Re: Record of Decision for the Fire Training Areas at the Seneca Army Depot Activity Superfund Site, Romulus, New York

# THE FIRE TRAINING AND DEMONSTRATION PAD (SEAD-25) and the FIRE TRAINING PIT AND AREA (SEAD-26)

# SENECA ARMY DEPOT ACTIVITY ROMULUS, NEW YORK

# **RESPONSE TO COMMENTS**

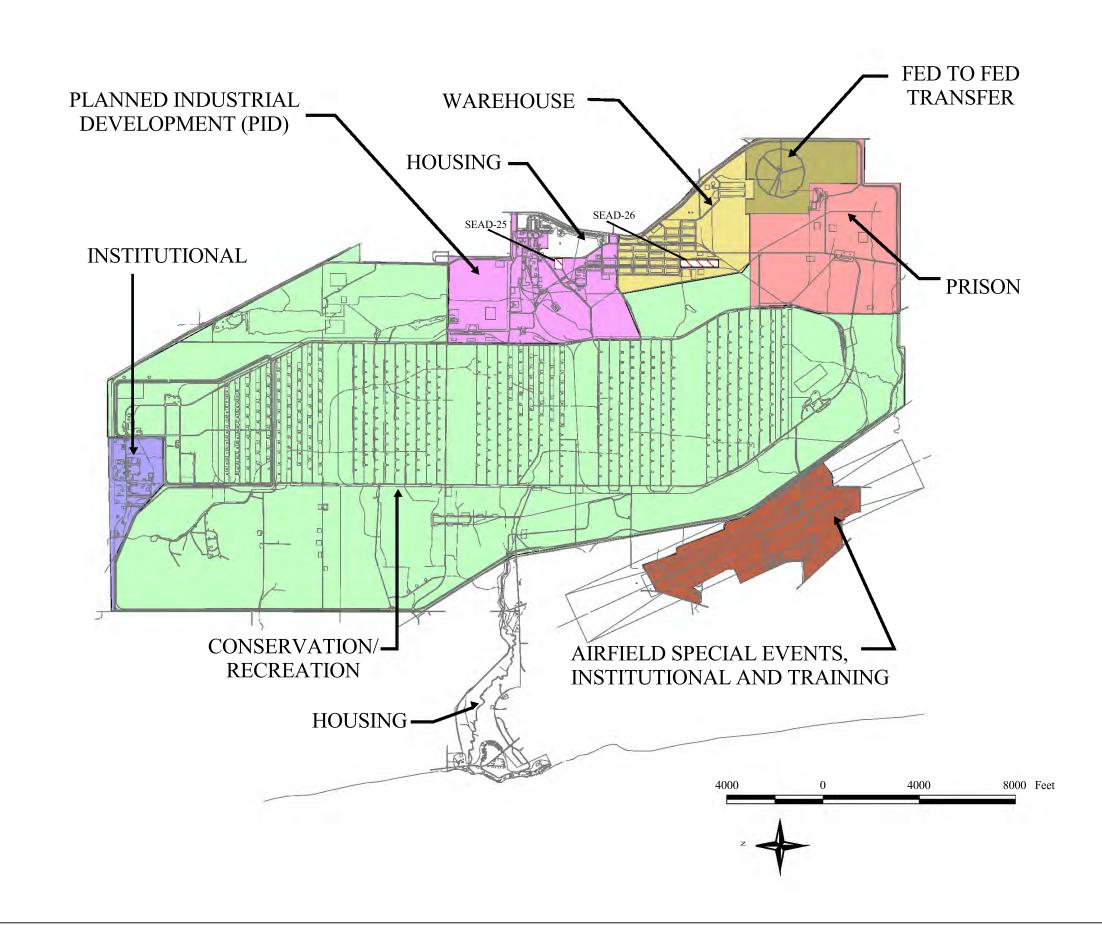
**Comment 50:** <u>Figure 3-2:</u> It would be helpful if this figure included the locations of SEADs 25 and 26.

**Response 50:** Assuming that the reference is to Figure 3-1, agreed. The location of SEAD-25/26 has been indicated on the map.

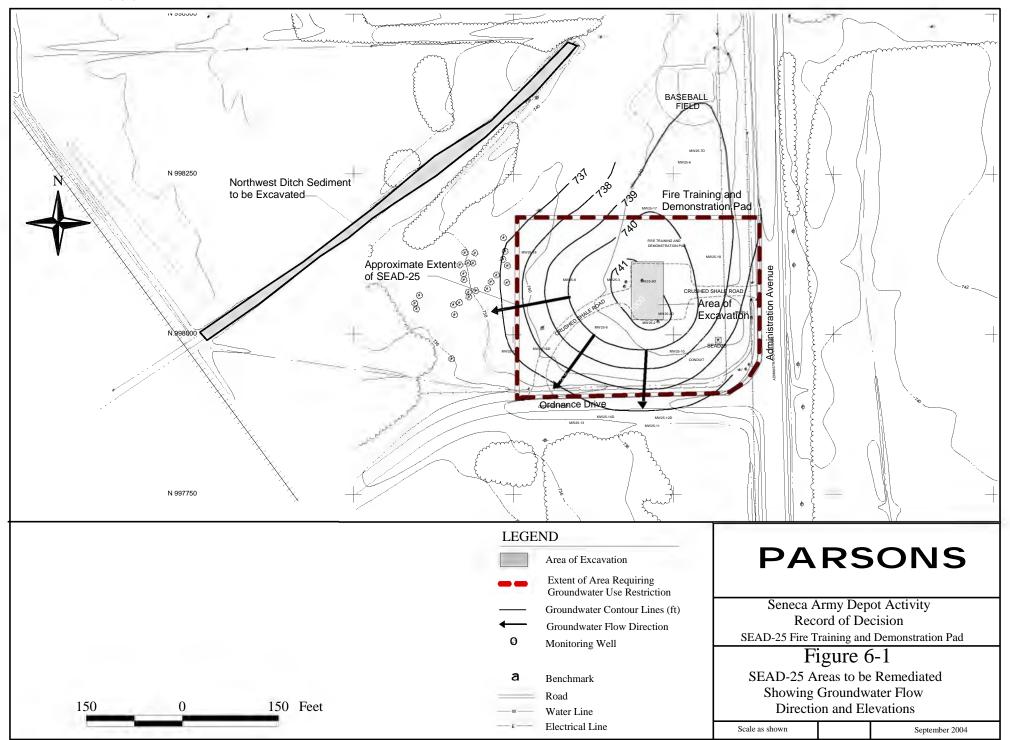
**Comment 49:** <u>Figure 6-1</u>: The groundwater flow direction in this figure does not correlate well with the plume sketches on Figure 6-2.

**Response 49:** Agreed. Figure 6-1 has been modified to more clearly illustrate the direction of groundwater flow. In addition, the following discussion on groundwater flow has been added to the text in Section 6.1.2, *Impacts to Groundwater*:

"The groundwater flow direction is shown in Figure 6-1. Results of groundwater contour mapping indicate that groundwater flow is radial below the pad, with a strong horizontal gradient to the south and west. The radial groundwater flow that has developed below the pad at SEAD-25 is believed to be a local phenomenon that is present because of the influence of the anthropomorphic bedrock topographic mound located below the pad. The mapping also indicated that the groundwater flow in the deeper portion of the aquifer located in the competent shale zone is to the west and southwest."

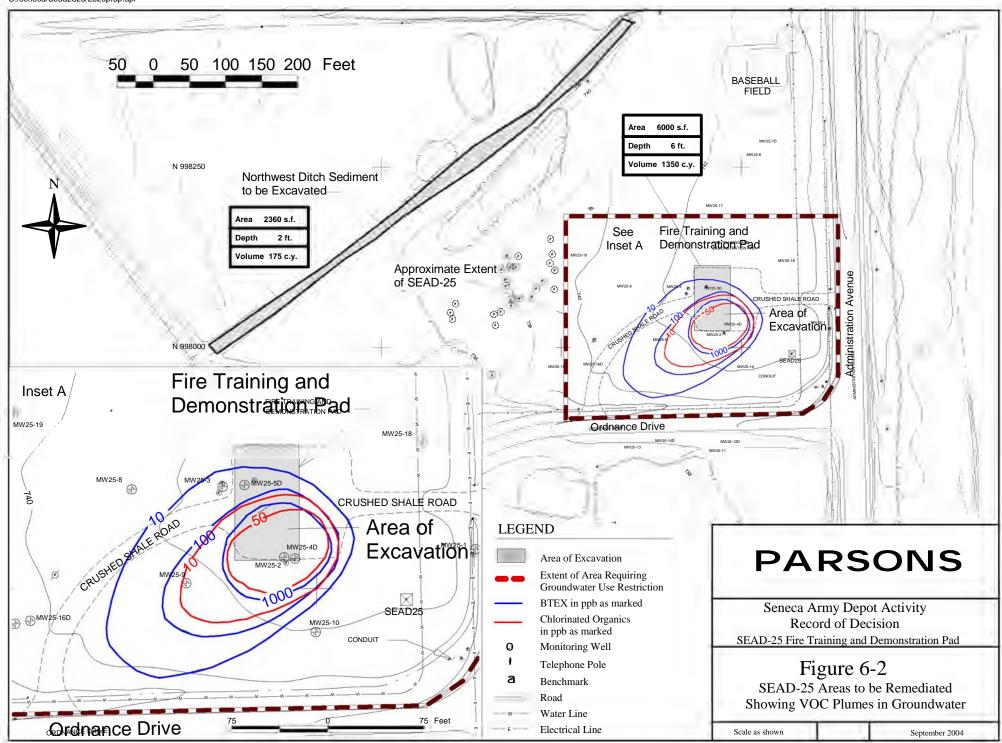
**Response 3:** Agreed. The areas requiring groundwater use restrictions without proper treatment until ARARs are achieved have been delineated on Figures 6-2 and 11-1 for SEAD-25 and SEAD-26, respectively. The concentrations in the outermost wells within the defined area comply with groundwater ARARs.

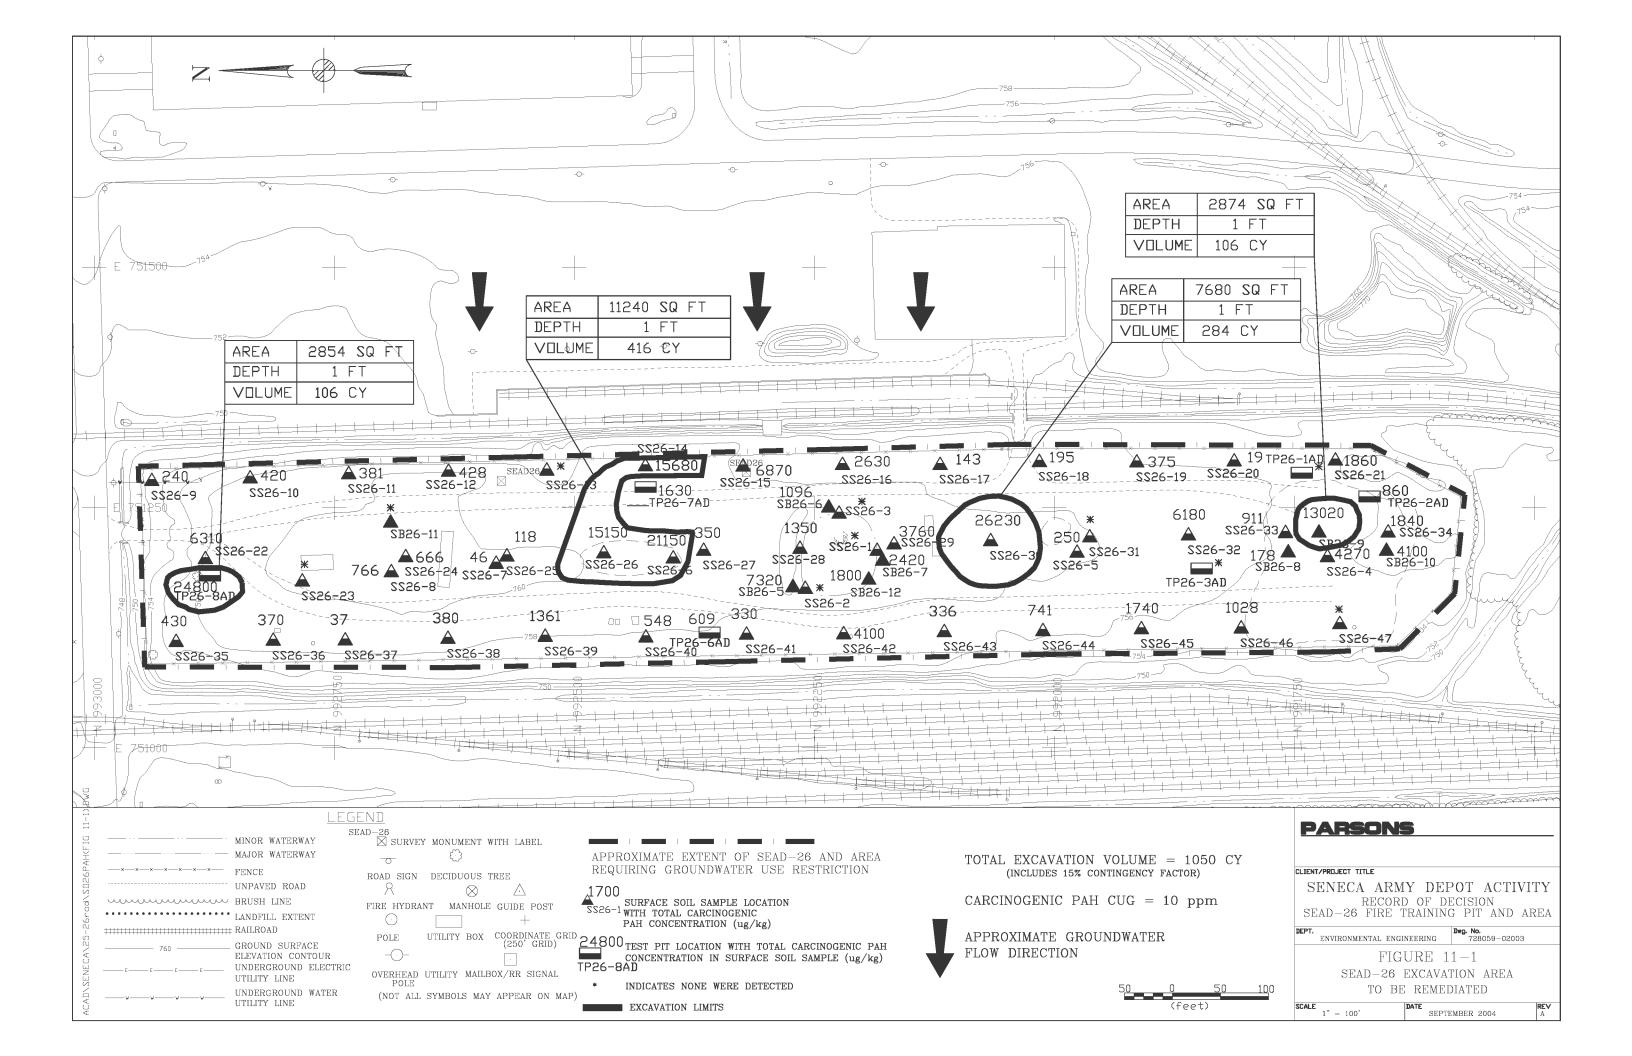
Also, in the last sentence of the paragraph above "State Concurrence," replace SEAD-25 with SEAD-26 right before "shown in Figure 11-1."

in a revised Figure 11-1. This remedial action will eliminate the need for any permanent land use restrictions at SEAD-26. However, a temporary groundwater use restriction will be imposed on the site until ARARs for groundwater are achieved. The following language on land use controls has been added to the ROD:

**Response 2**: Acknowledged. The preferred remedy for SEAD-26 has been revised to include excavation of soils and ditch soils with total carcinogenic PAH concentrations above 10 ppm, for an estimated total volume of 1050 CY. The area of excavation is presented in a revised Figure 11-1. This remedial action, which received concurrence from the EPA in an email dated 2/20/2003, will eliminate the need for any permanent land use control. Therefore, there will not be a residential or daycare land use restriction at SEAD-26. It should be noted that a temporary groundwater use restriction will be imposed on the site until ARARs for groundwater are achieved. The text has been revised accordingly.

with 10 ppm as a cleanup goal would be 1200  $\mu$ g/kg and 410  $\mu$ g/kg, respectively. The area of excavation is presented in a revised Figure 11-1. Land use controls in the form of a groundwater restriction will be an element of the remedy until NYSDEC Class GA groundwater standards are achieved. Details on the implementation and enforcement of the land use controls will be specified in the remedial design plan.
